UNITED STATES
NUCLEAR REGULATORY COMMISSION
WASHINGTON, D.C. 20555-0001

SUBJECT: COOPER NUCLEAR STATION - STAFF ASSESSMENT OF INFORMATION PROVIDED PURSUANT TO TITLE 10 OF THE *CODE OF FEDERAL REGULATIONS* PART 50, SECTION 50.54(f), SEISMIC HAZARD REEVALUATIONS FOR RECOMMENDATION 2.1 OF THE NEAR-TERM TASK FORCE REVIEW OF INSIGHTS FROM THE FUKUSHIMA DAI-ICHI ACCIDENT (TAC NO. MF3734)

STAFF ASSESSMENT BY THE OFFICE OF NUCLEAR REACTOR REGULATION

COOPER NUCLEAR STATION

Figure 3.3-1 Plot of Staff's and Licensee's Base Case Shear-Wave Velocity Profiles for the Cooper Nuclear Station site

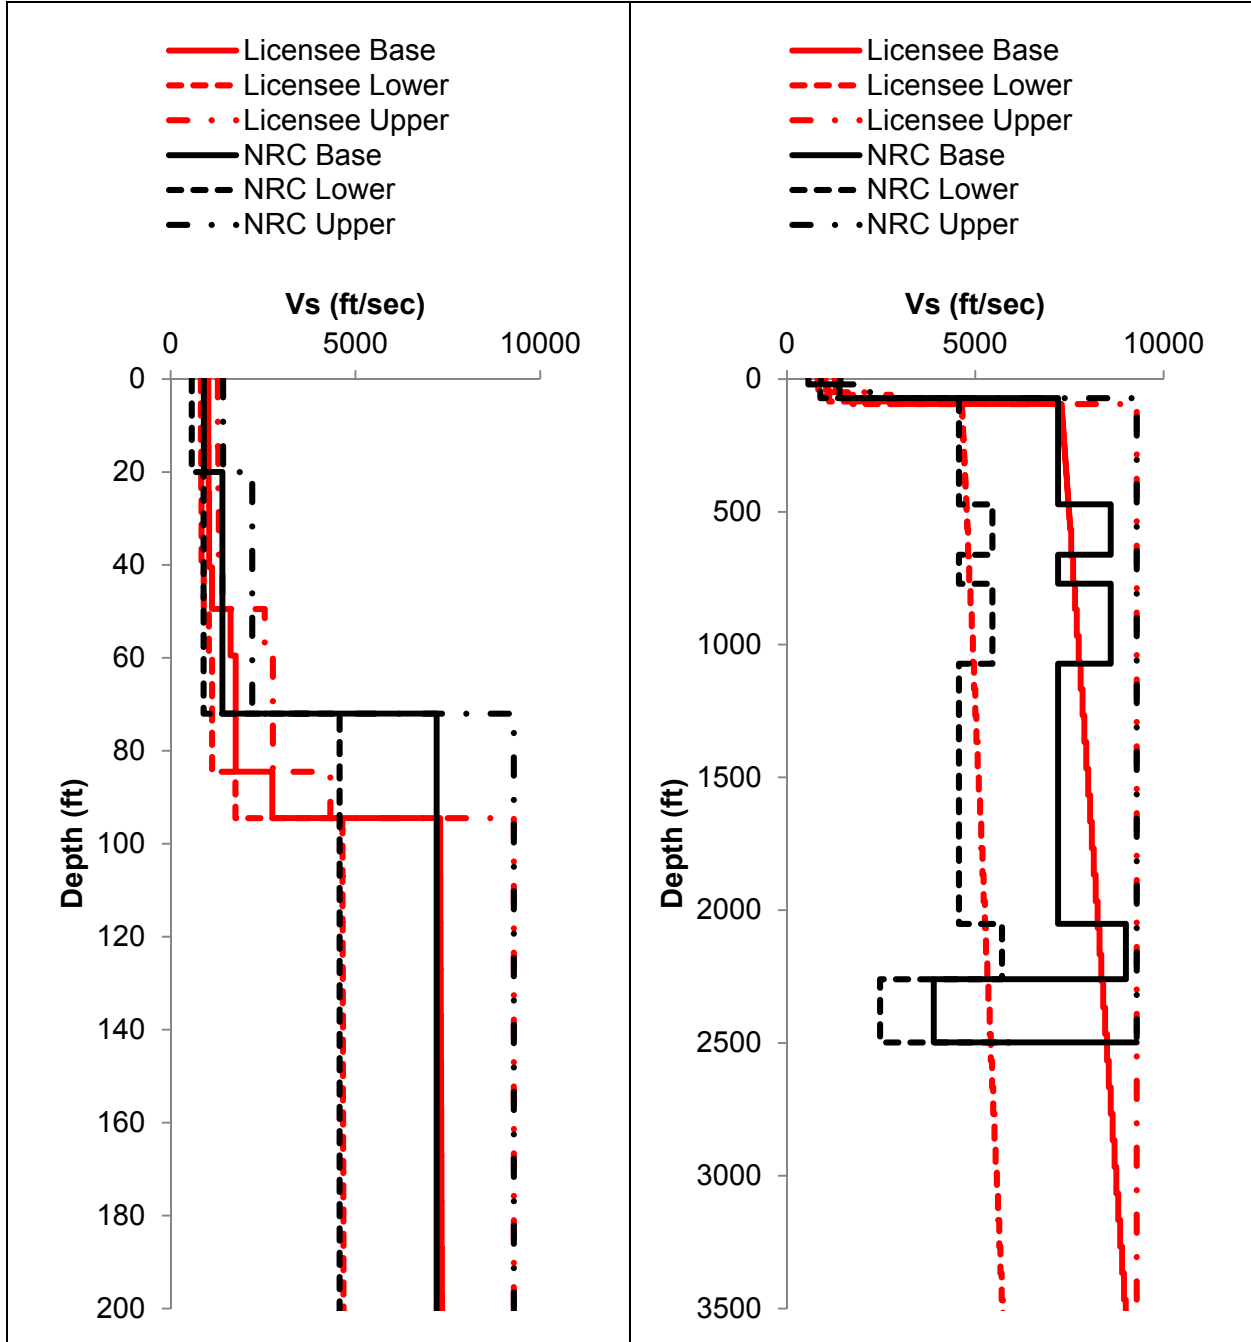
To characterize the subsurface geology, the licensee developed three site base case profiles. For the middle, or best estimate, profile, the licensee estimated a value of 7,292 ft/s [2,223 m/s] for the firm rock layers below a depth of 128 ft [39 m] based on the lithology of the rock. To develop the upper and lower base case profiles, the licensee used a scale factor of 1.25 for the upper 49.5 ft (15 m) and 1.57 below to reflect increased uncertainty for assumed shear wave velocities. Figure 3.3-1 of this assessment shows the licensee's three shear-wave velocity base case profiles.

To characterize the uncertainty in the subsurface material properties, the NRC staff developed three separate profiles. The NRC staff's shear wave velocity profiles are very similar to those submitted by the licensee in the upper 80 ft, but differ somewhat below 80 ft. The differences are due to the NRC staff's use of the shear wave velocities for similar rock units at other nuclear sites in the region while the licensee used a generic velocity profile from the SPID. The NRC staff's base case shear-wave velocity profiles along with the licensee's base case profiles are shown in Figure 3.3-1 of this assessment.

Figure 3.3-2 Plot Comparing the Staff's and the License's Median Amplification Functions and Uncertainties for two input loading levels for the Cooper Nuclear Station site

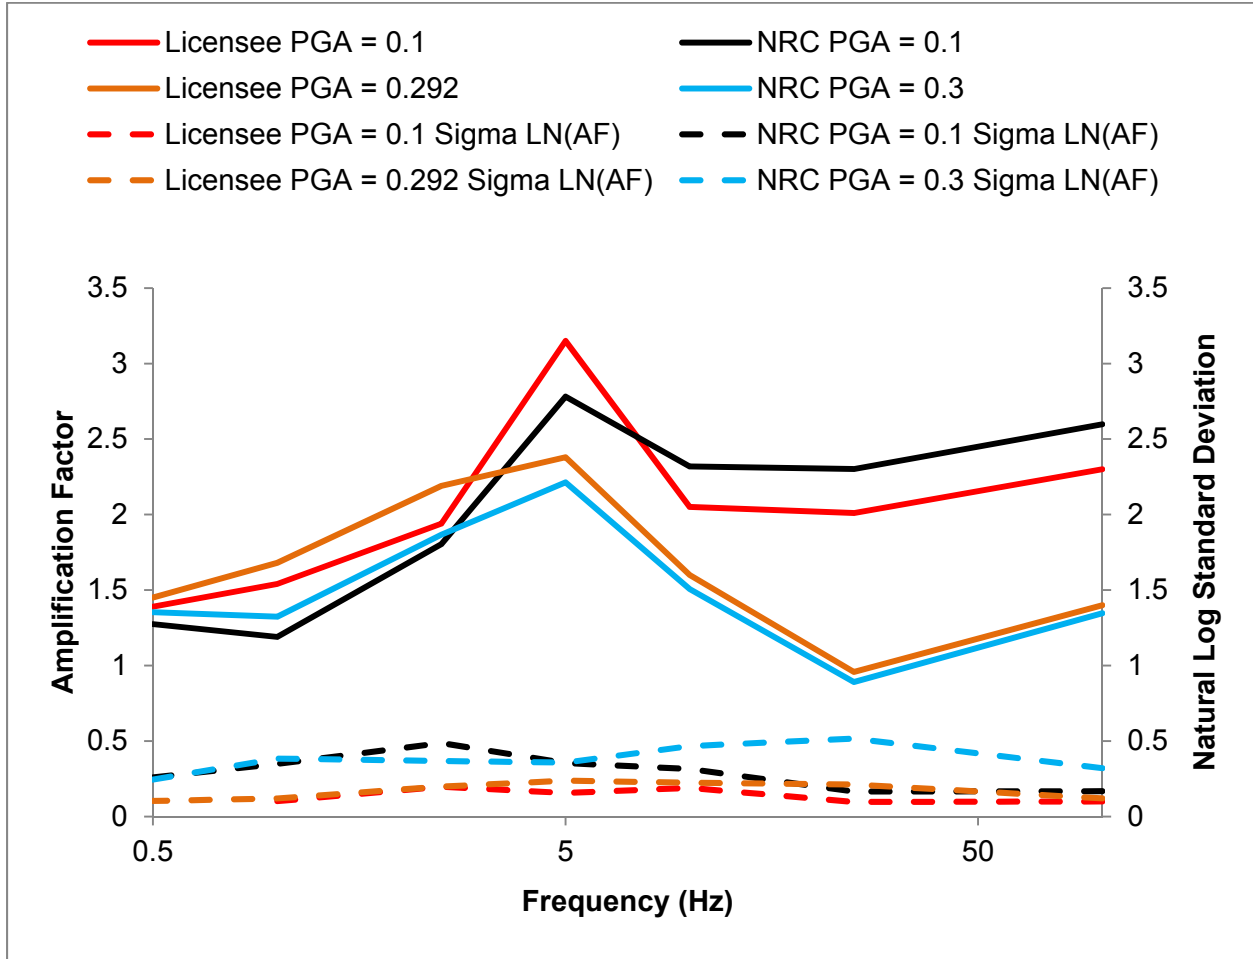
Figure 3.3-2 of this assessment shows a comparison of the NRC staff's and licensee's median site amplification functions and uncertainties for two of the eleven input loading levels for profiles used in the licensee's SHSR submittal. As shown in Figure 3.3-2, the differences between the NRC staff's and licensee's amplification functions and uncertainties are very minor. Figure 3.3-3 of this assessment compares the control point hazard curves at 1 Hz, 10 Hz, and PGA developed by the NRC staff with those developed by the licensee in its SHSR. Again the licensee's and NRC staff's control point hazard curves are very similar. These small differences in the site response analysis do not have a large impact on the control point seismic hazard curves or the resulting GMRS, as discussed below.

Figure 3.4-1 Comparison of the Staff's GMRS with Licensee's GMRS and the SSE for the Cooper Nuclear Station site

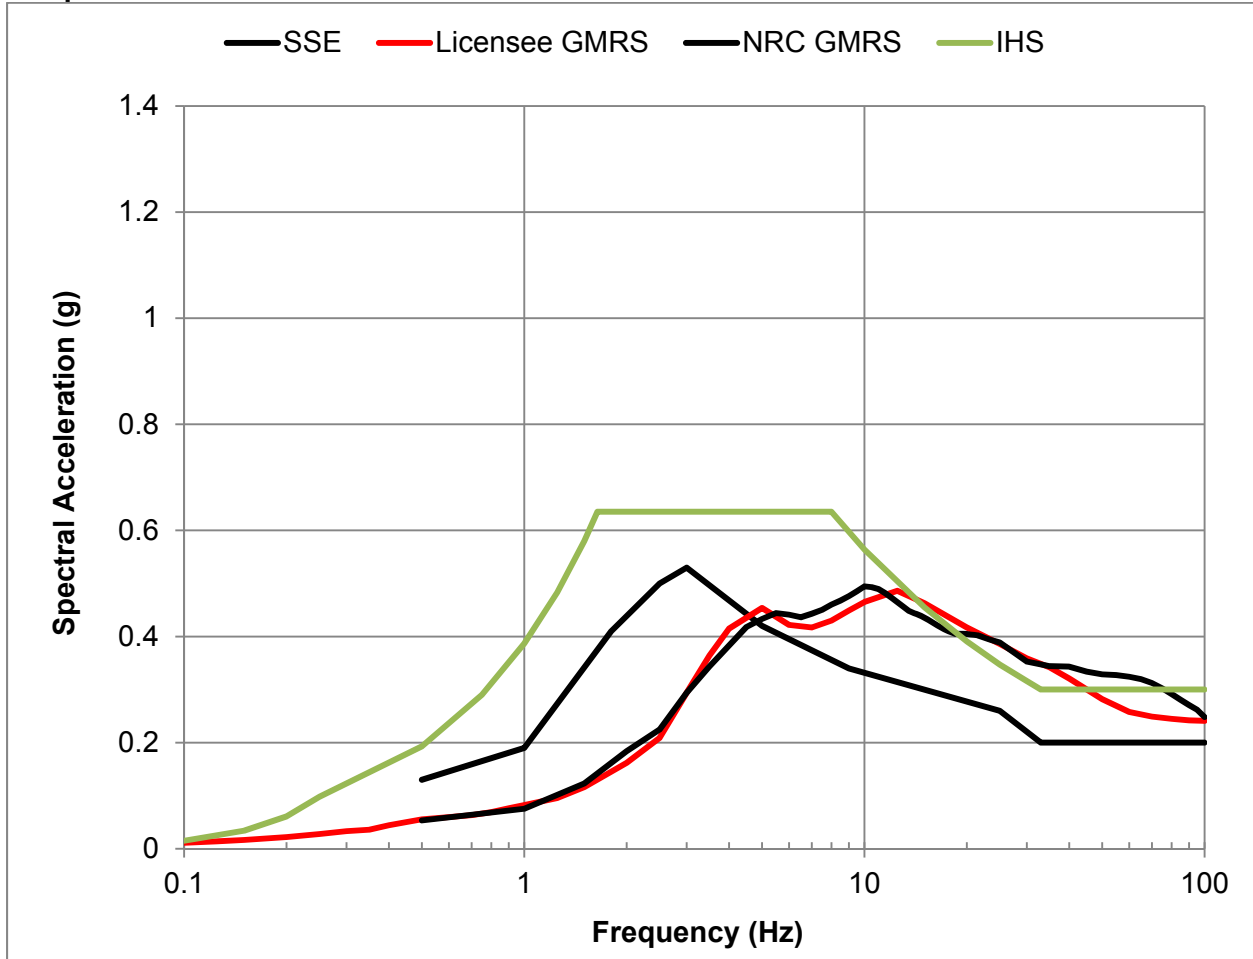
The NRC staff independently calculated the 10^{-4} and 10^{-5} UHRS using the results of its confirmatory PSHA and site response analyses, as described in Sections 3.2 and 3.3 of this staff assessment, respectively. Figure 3.4-1 of this assessment shows a comparison of the GMRS determined by the licensee to that determined by the NRC staff. As shown in Figure 3.4-1, the licensee's GMRS is very similar to that determined by the NRC staff.

The NRC staff confirms that the licensee used the present-day guidance and methodology outlined in RG 1.208 and the SPID to calculate the horizontal GMRS, as requested in the 50.54(f) letter. The NRC staff performed both a PSHA and site response confirmatory analysis and achieved results consistent with the licensee's horizontal GMRS. As such, the NRC staff concludes that the GMRS determined by the licensee adequately characterizes the reevaluated hazard for the CNS site. Therefore, this GMRS is suitable for use in subsequent evaluations and confirmations, as needed, for the response to the 50.54(f) letter.
